STATE LOOP 360

CSJ 5000-00-131

**CONTEXT SENSITIVE SOLUTIONS
SUMMARY**

Loop 360 Context Sensitive Solutions Report August 2019 Workshop and Survey Feedback

WALL TREATMENTS

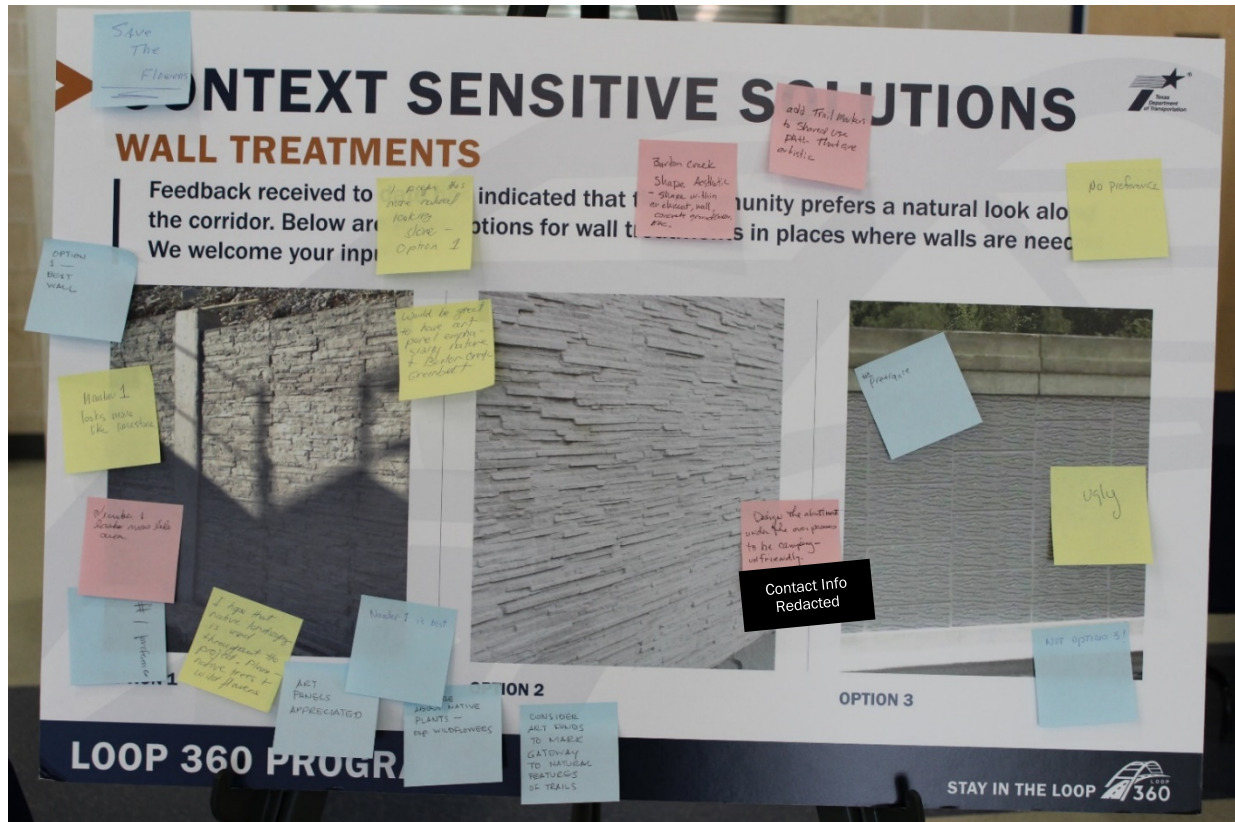
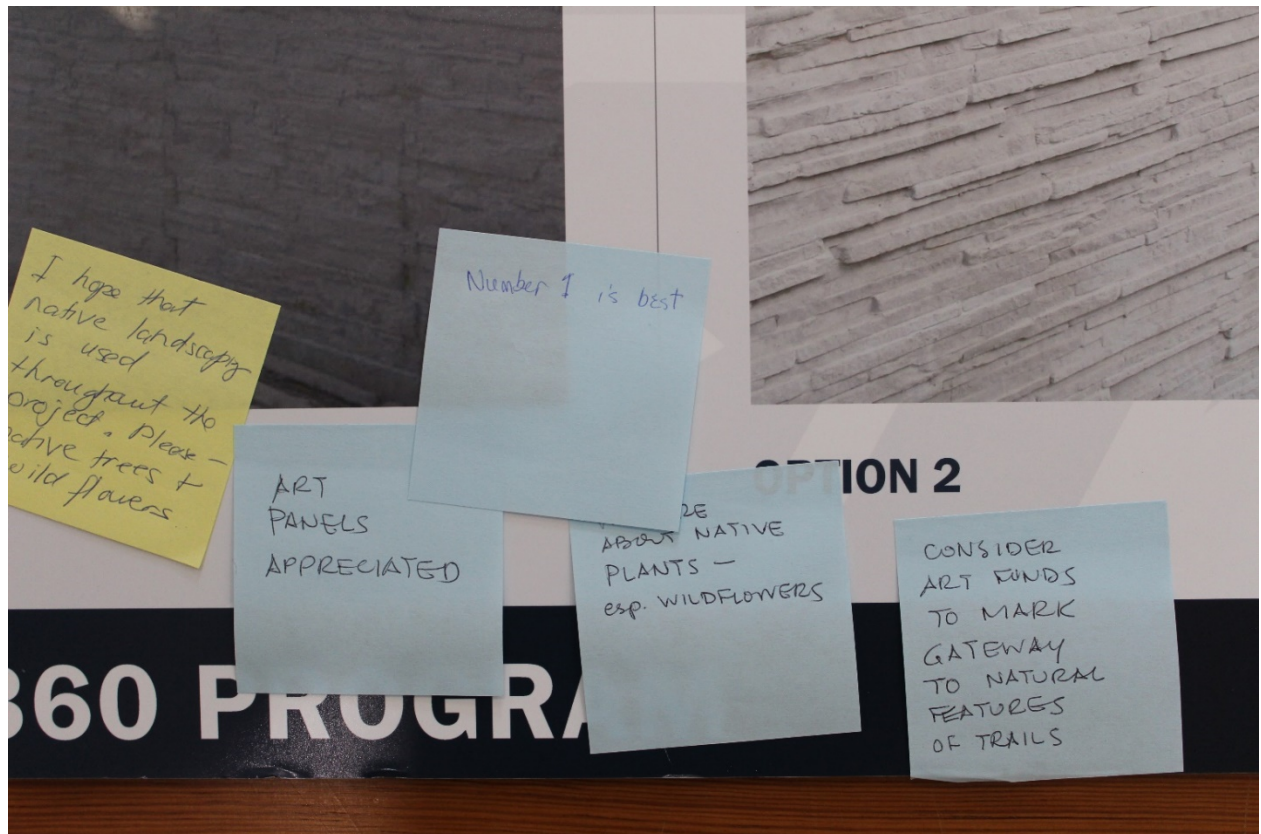
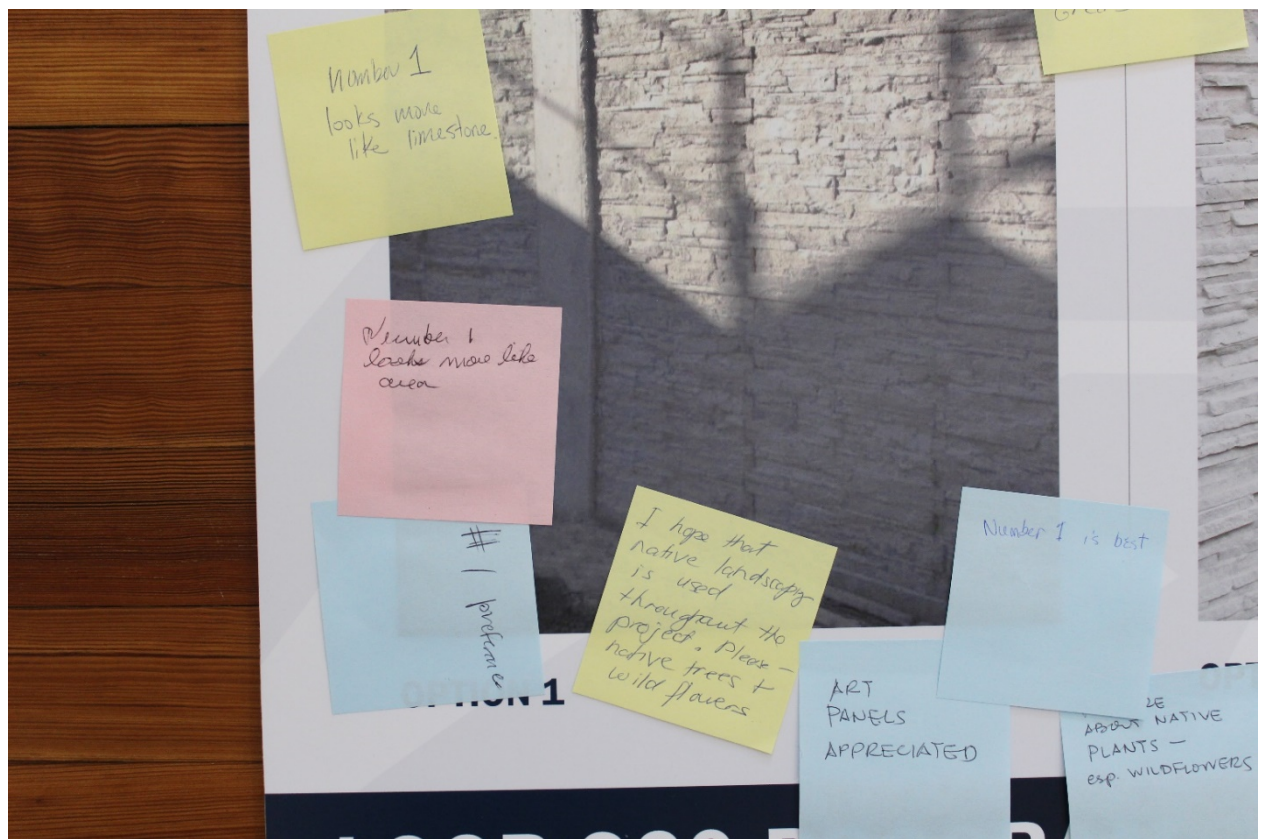
Participants tended to prefer Option 1 for Loop 360, commenting that it resembles limestone and is relatively natural looking. Option 2 received some support, and participants disfavored Option 3. Some respondents commented that the options seemed too neutral or were not aesthetically pleasing.

Respondents commented that noise reduction and amount of right of way required are important factors for the walls. They also requested that walls be made of a material that allows for easy removal of graffiti.

NOT options 3!

1	Option 1
2	Like the look of Options 1 and 2
3	Those are all really boring looking. Y'all can do better
4	I think it would be good, but it depends on how well it reduces noise for residences in the neighborhoods, as well as how much Right Of Way it takes up.

1	All those lame options
2	They are not aesthetically pleasing and take away the natural view of the greenbelt and other views along this portion of Loop 360.

1	It would be nice if they are made of a material that can be sandblasted to remove graffiti. All these types of walls start out nice, and then look terrible later. For example, look at the Pennybacker bridge. Graffiti has been painted over on the rusted steel, but
---	---

perhaps some kind of removal could have been done instead. Or, at least match the paint color to the steel.

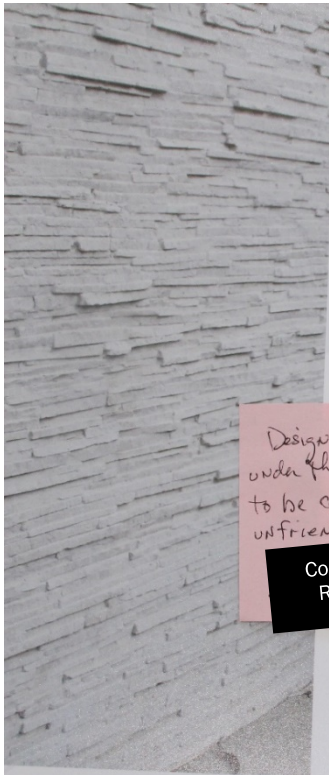
add Trail Markers
to Shared Use
PATH that are
artistic

Shape Aesthetic

- shape within
an element, wall,
concrete groundcover,
etc.

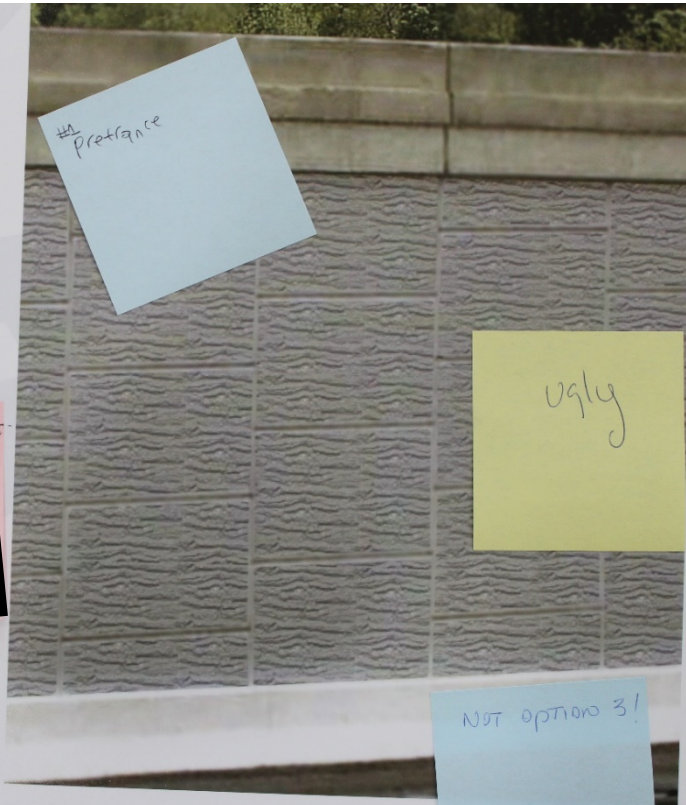
Design the abutment
under the overpasses
to be camping-
unfriendly.
